From: Keen, Shelley
Sent: Monday, May 15, 2006 8:26 AM
To: Wilson, Keith
Subject: RE: Dee Lynn Wood POU 31-7567/7560A & 31-7560B

From: Wilson, Keith
Sent: Thursday, May 11, 2006 3:32 PM
To: Keen, Shelley
Subject: Dee Lynn Wood POU 31-7567/7560A & 31-7560B

<< File: wood_b31.jpg >> << File: wood_b31_pou.jpg >>

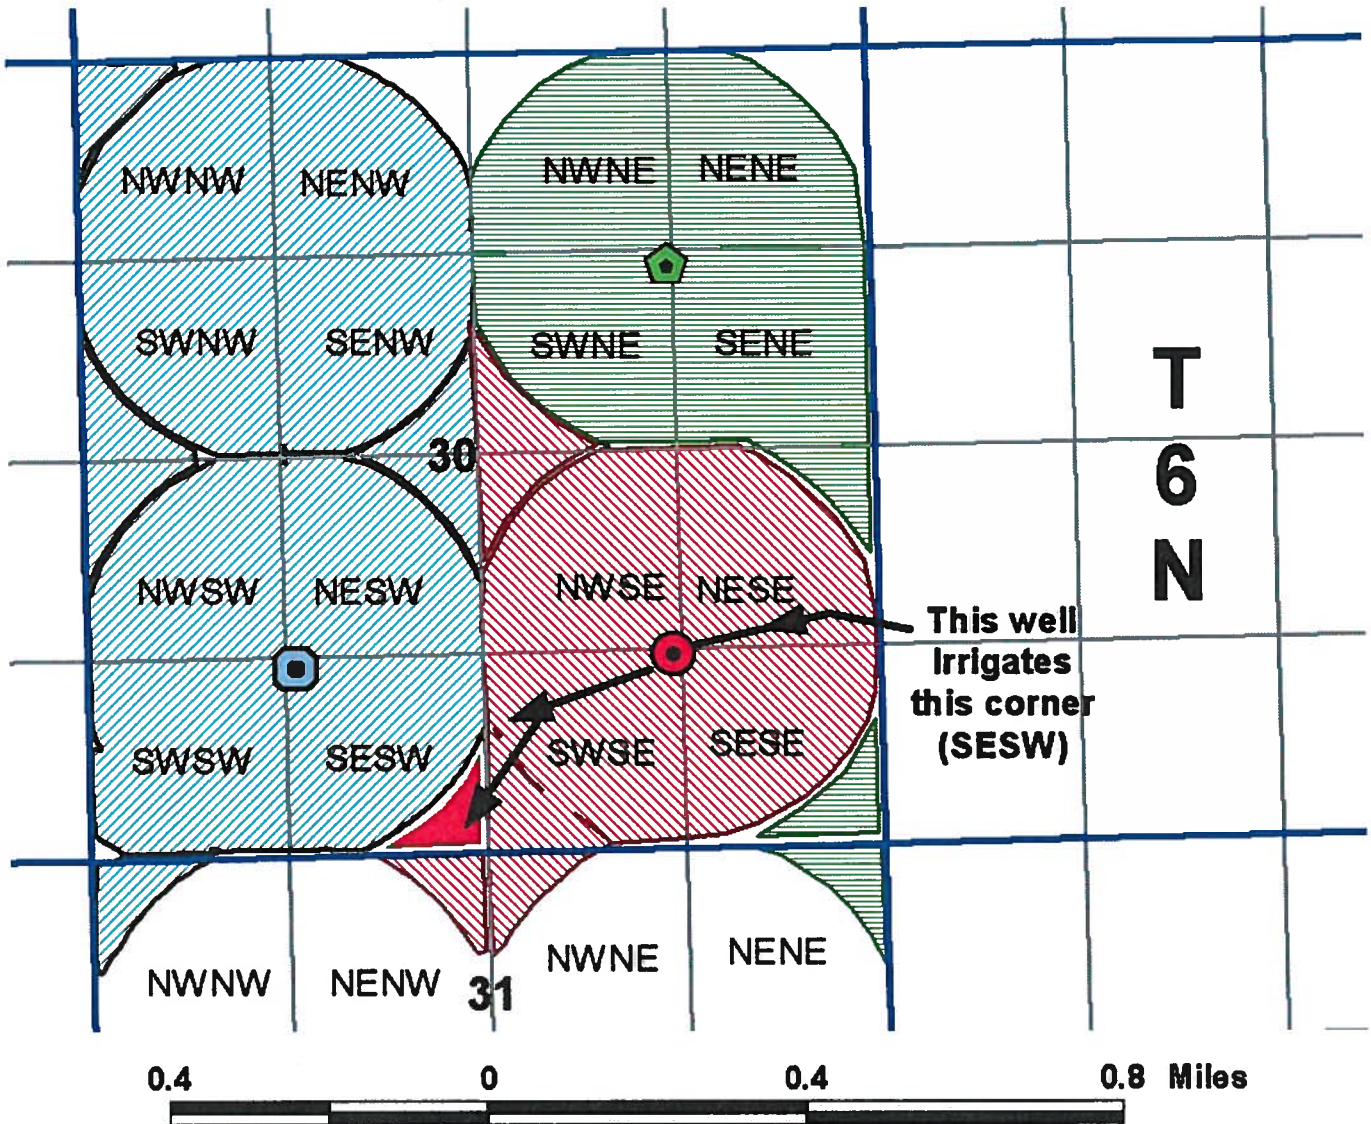
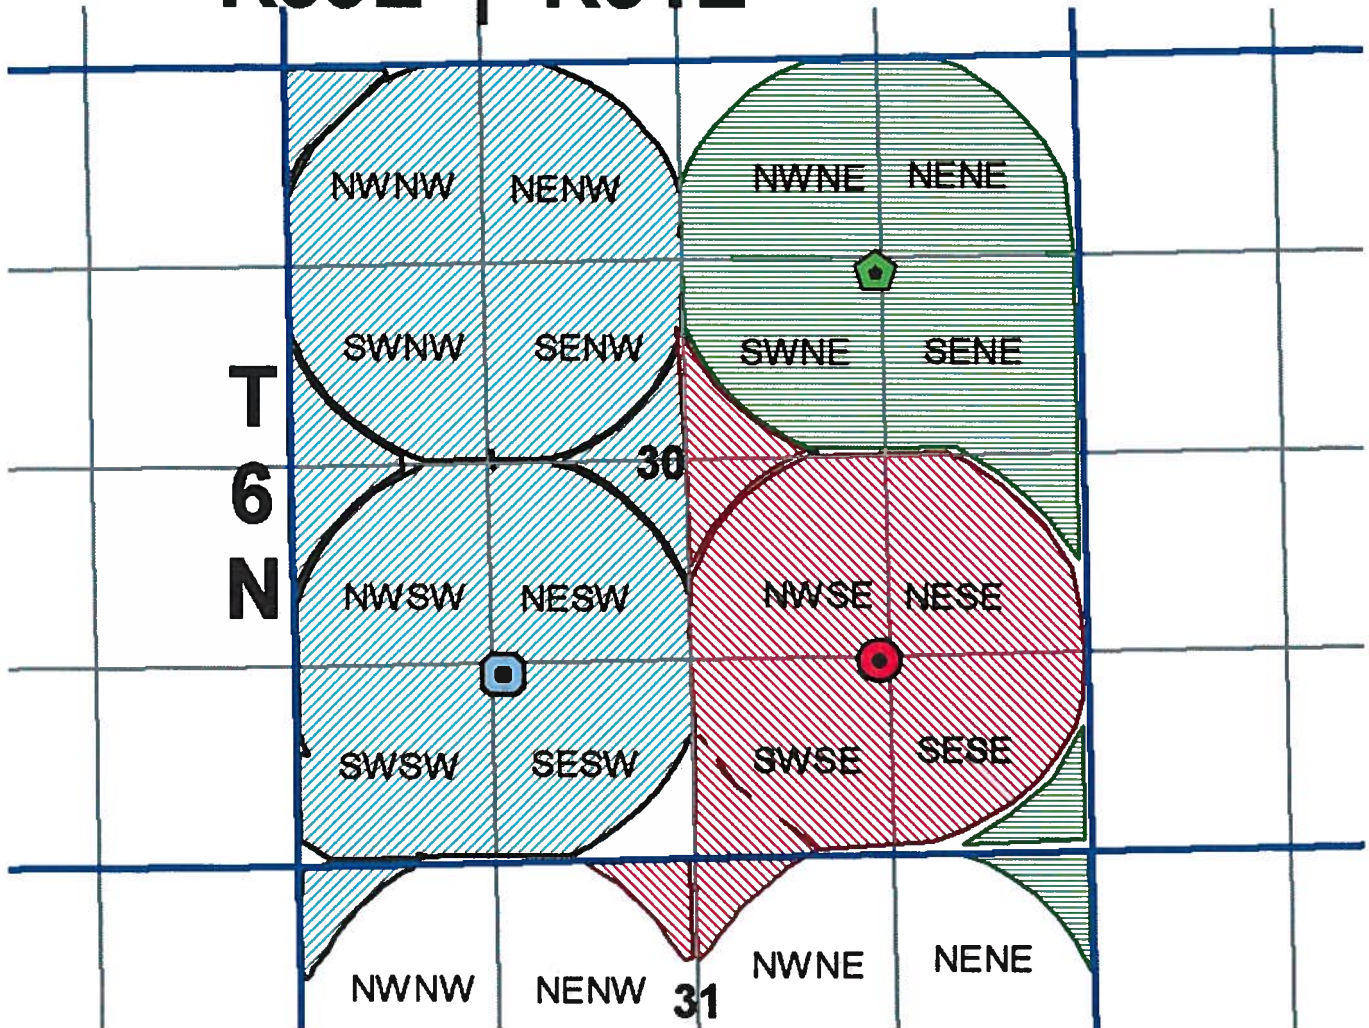
Also I am attaching a map of the place of use of 31-7560A, 31-7560B & 31-7567 using ArcView shapes. The Proof report for right 31-7560B lists 6 ac in the SENE Sec 30, T6N, R34E, but the shape file in ArcView shows the use in the SWNE Sec 30, T6N, R34E, with 31-7560A irrigating the SENE Sec 30, T6N, R34E. Also 31-7567 irrigates the four corners in the center of Sec 30. This causes an overlap of 31-7560B & 31-7567 in the SWNE & NWSE Sec 30.

Mr. Wood should file a transfer for 31-7560B to move water to the SESW Sec 30. He may have to reduce the total acres under 31-7560B, then file the licensing amendment for 31-7567 changing the place of use to cover the 320 acres under the new shape. By filing the transfer as proposed he will take care of 31-7560B. I'm not sure he would like to reduce acres under 31-7560B, but I based this recommendation on using the earliest priority (31-7567) covering the place of use. Do you see a better way the accommodate Mr. Wood?

If you're sure that Mr. Wood has not been changing the system and enlarging his use in recent years, send me a supplemental field report revising your POU recommendation for 31-7576. I don't think Permit 31-7576 has enough acres to cover 3 more pivot corners, but perhaps it can cover 2 more. Mr. Wood may need to file two transfer applications for Right 31-7560B. One should move a pivot corner from the middle of Section 30 down to the SESW of 30. The second should split off a pivot corner in the middle of Section 30 and change its POD to the well in the SESW of 30.
